From: Detterman, Mark, Env. Health
Sent: Wednesday, June 06, 2012 9:05 AM
To: 'Sami Malaeb'
Cc: rbatiste@eec-corp.com; colisa@me.com; britpete@aol.com
Subject: RE: 2145 35th Avenue, Oakland, CA - Petroleum Hydrocarbons in Water - Calculated Groundwater Flow Direction - Proposed Well Locations - Well Diagram -

Please use this email to document that ACEH is in **general concurrence with the revised proposed well locations** as proposed in Figure 5.

FIGURE 6
JUNE 2012

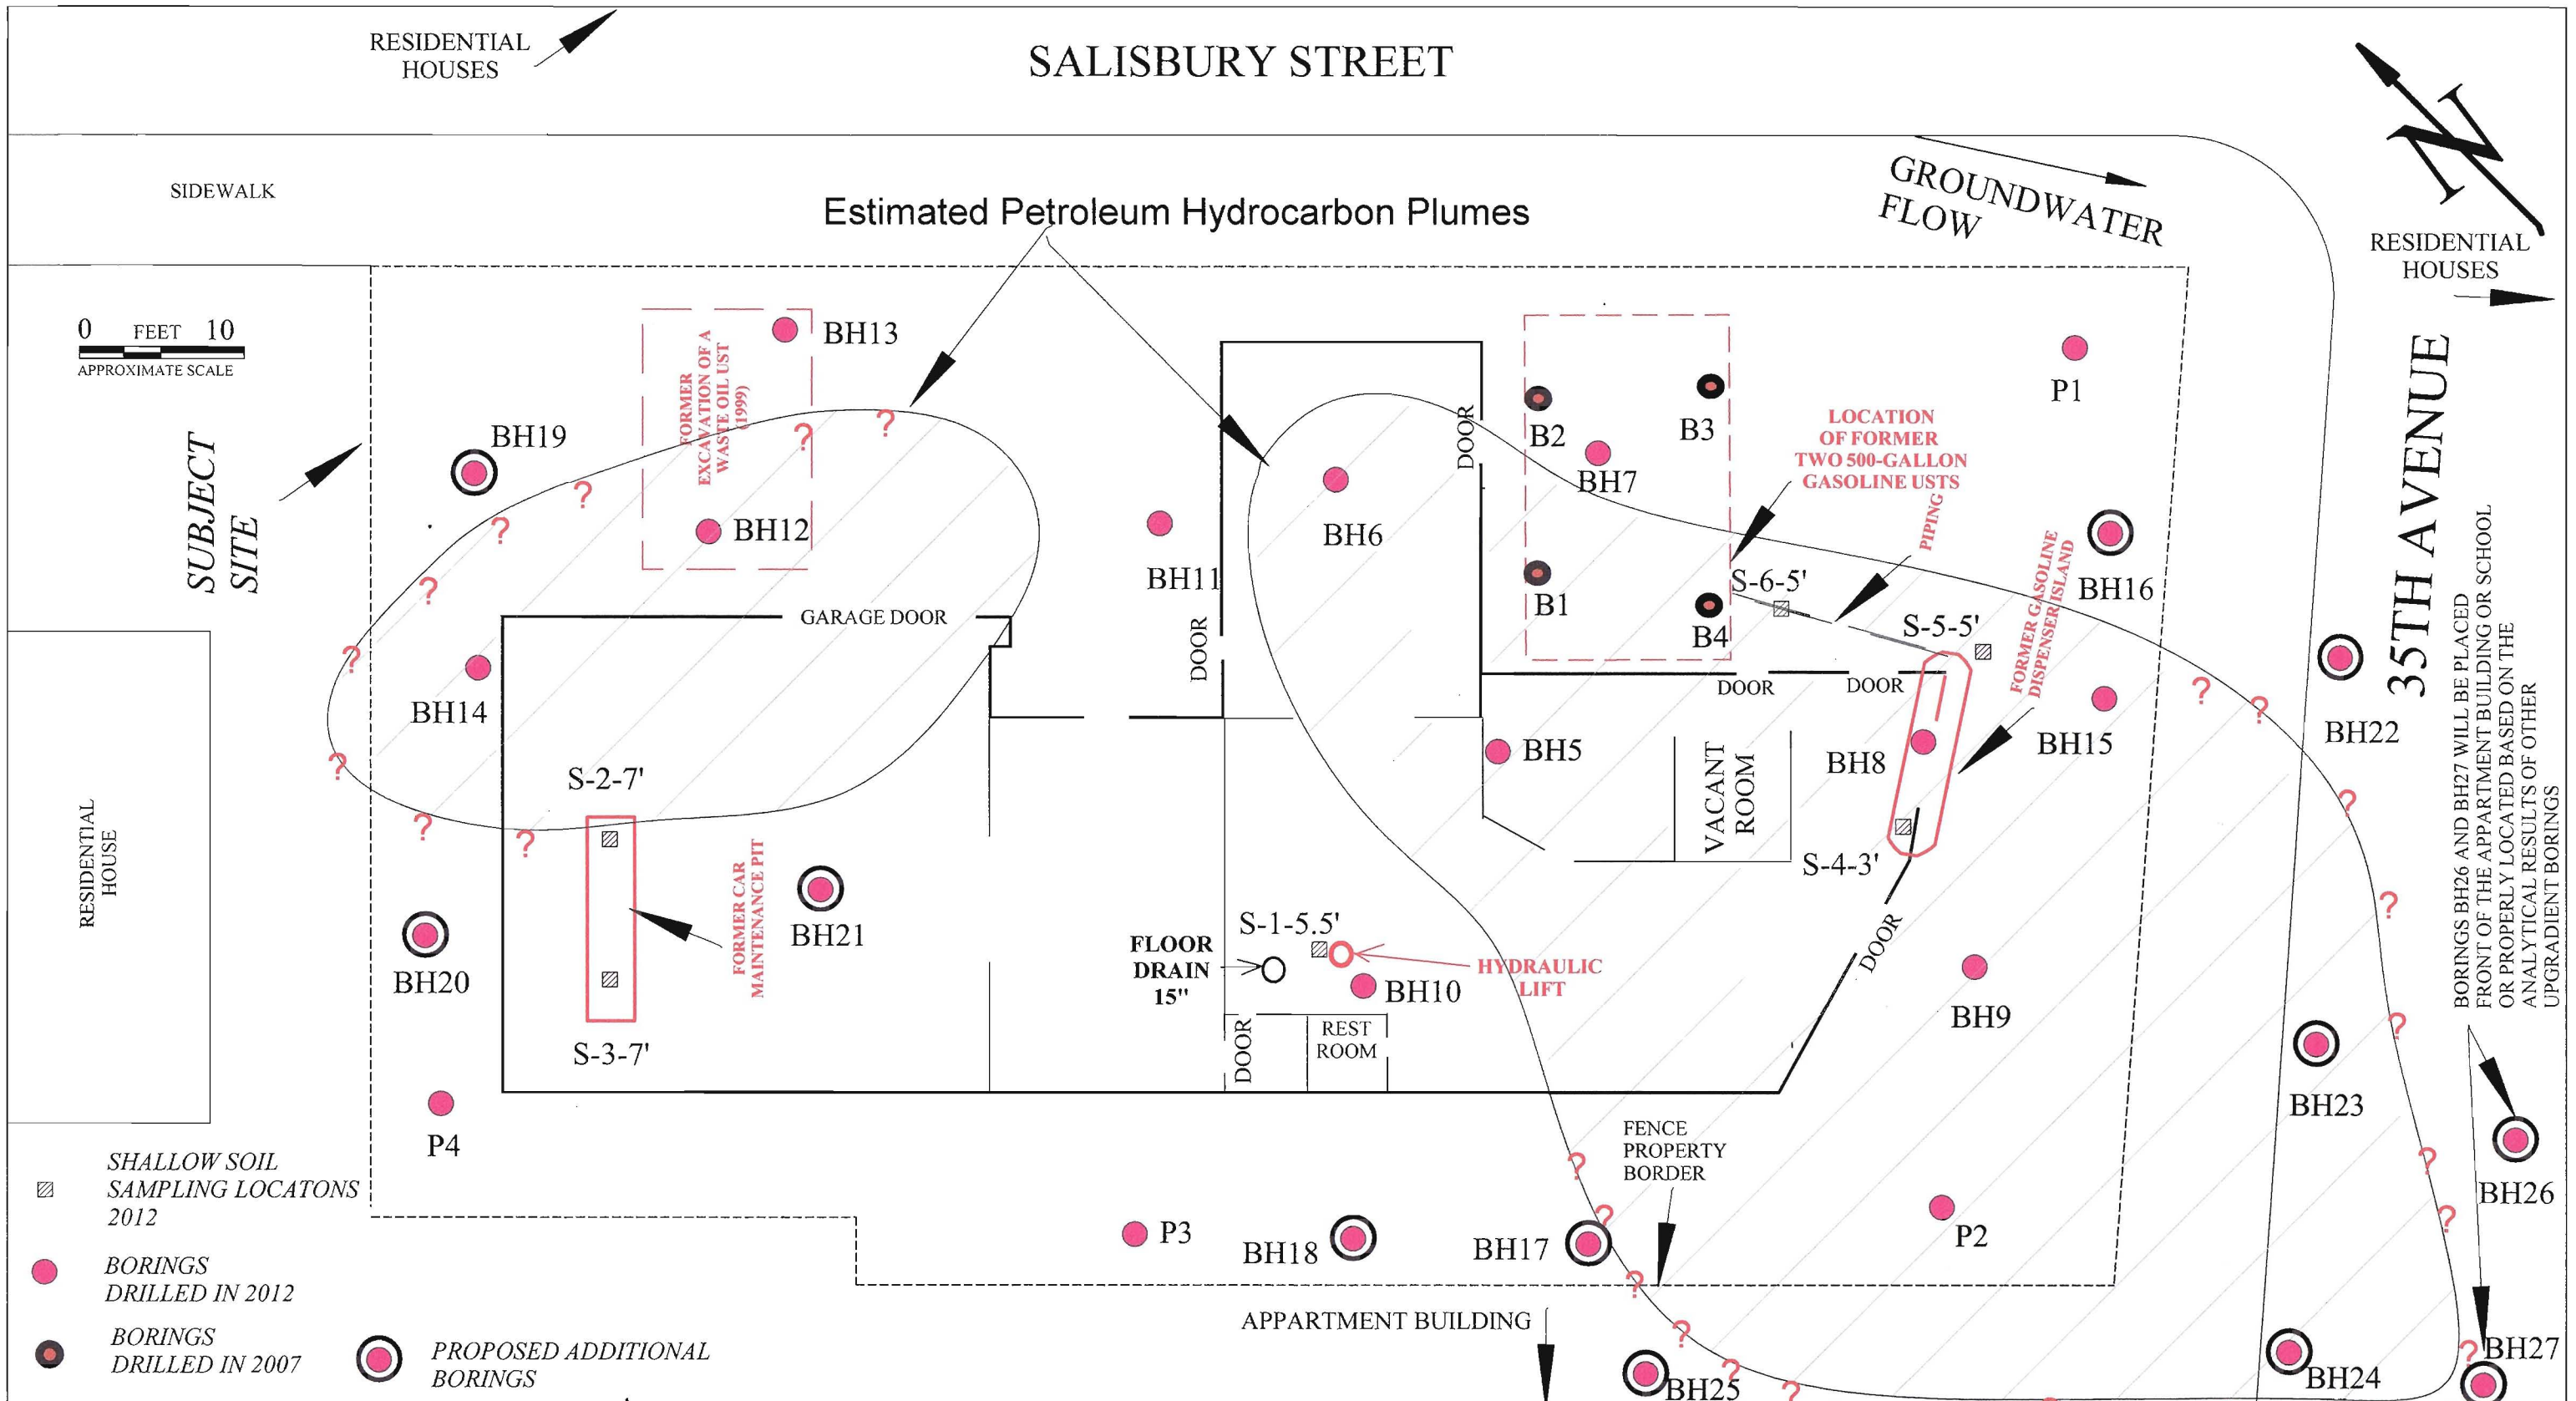
For the next Phase, after installing the four monitoring wells, I recommend drilling an additional Twelve (12) borings BH16 through BH27 and up to six (6) additional monitoring wells (onsite and offsite). In the meanwhile, if floating product is encountered in the monitoring wells, interim remediation or skimming will be in order. The attached Figure 4 contains the concentrations of Petroleum Hydrocarbons in groundwater. Figure 6 depicts the estimated extent of the plume and the proposed additional boring locations. The borings and wells will be installed according to the already approved workplan. Also, fuel oxygenates, lead scavengers, and volatile organics will be eliminated from future analysis (except TPH-G; BTEX; TPHss; MTBE; TPH-D; TPH-Mo, Five Metals, and Naphthalene will stay in the analysis). As you

BORINGS BH26 AND BH27 WILL BE PLACED FRONT OF THE APARTMENT BUILDING OR SCHOOL OR PROPERLY LOCATED BASED ON THE ANALYTICAL RESULTS OF OTHER UPGRADIENT BORINGS

ACEH is in general agreement with the scope of site investigation work you have proposed; however, as always the devil's in the details. ACEH will withhold concurrence on the proposed bore locations (or exact number) pending availability of the results of the four wells planned for installation in the near future. Please plan for a work plan to formally propose locations for the bores and wells and other appropriate future actions (this can be combined with the results of the site investigation). Thanks for keeping me (and ACEH) up to date on actions at the site.

FIGURE 4
APRIL 2012

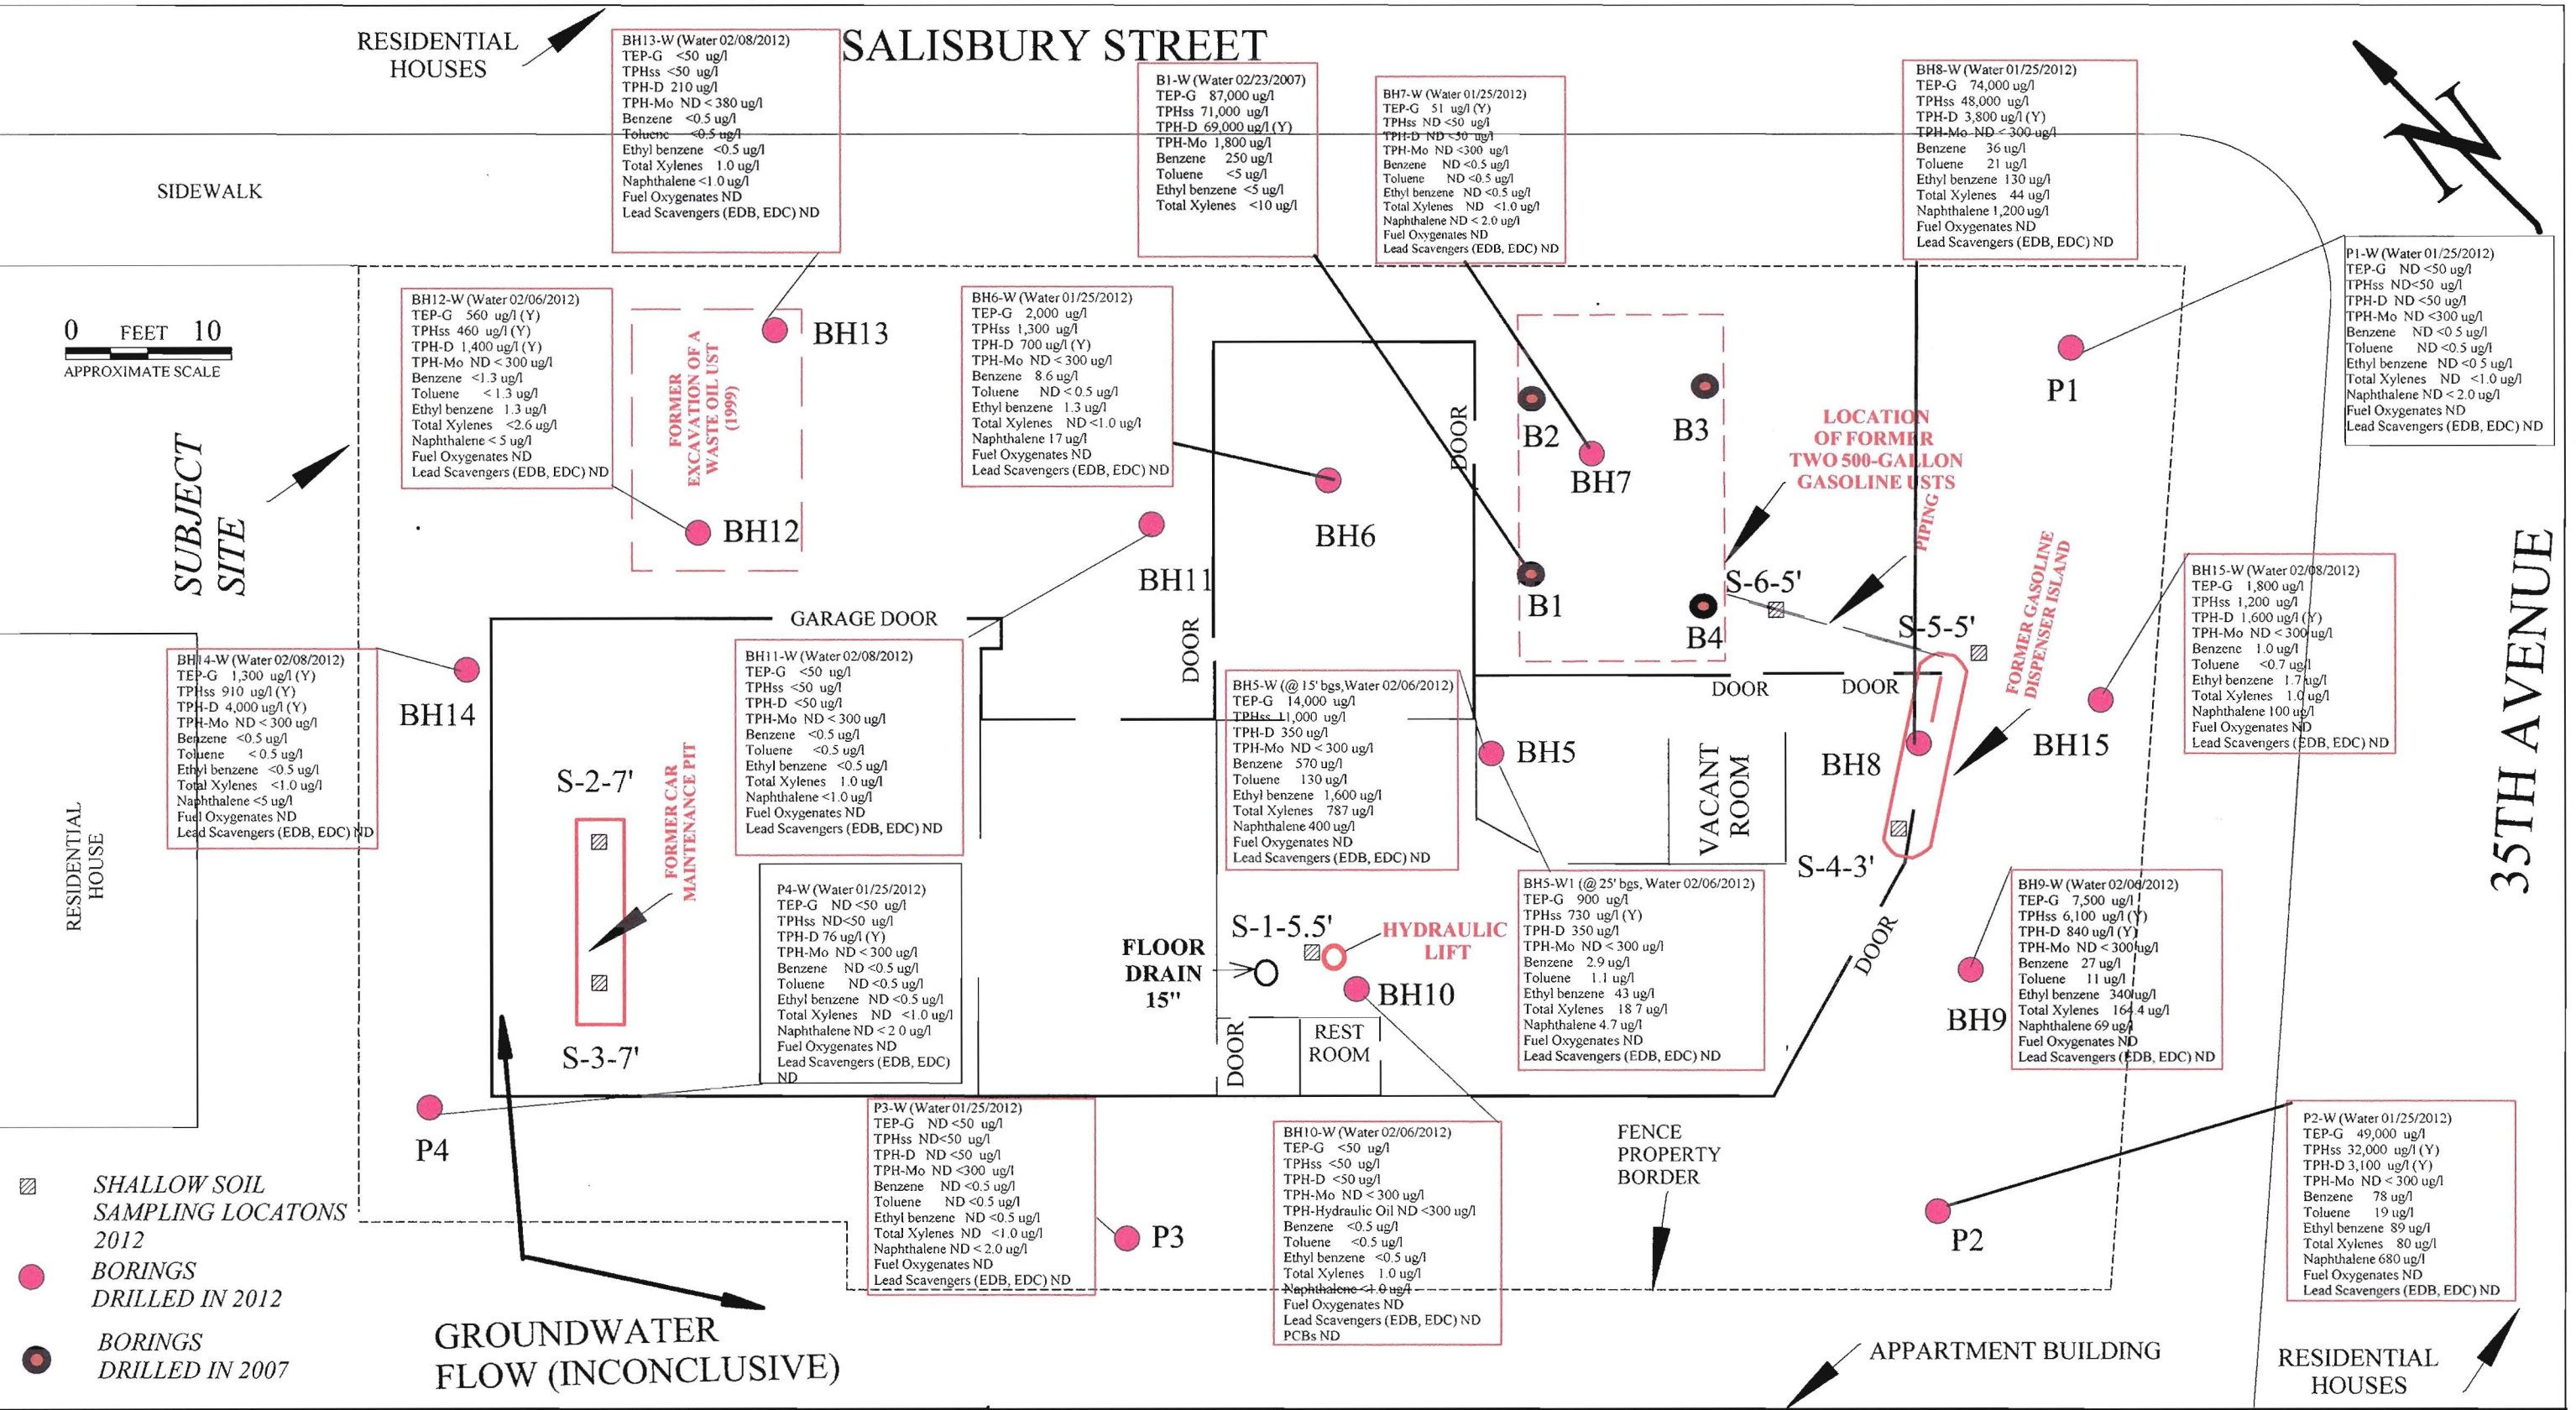
For your reference, Figure 4 depicts petroleum hydrocarbons in groundwater.
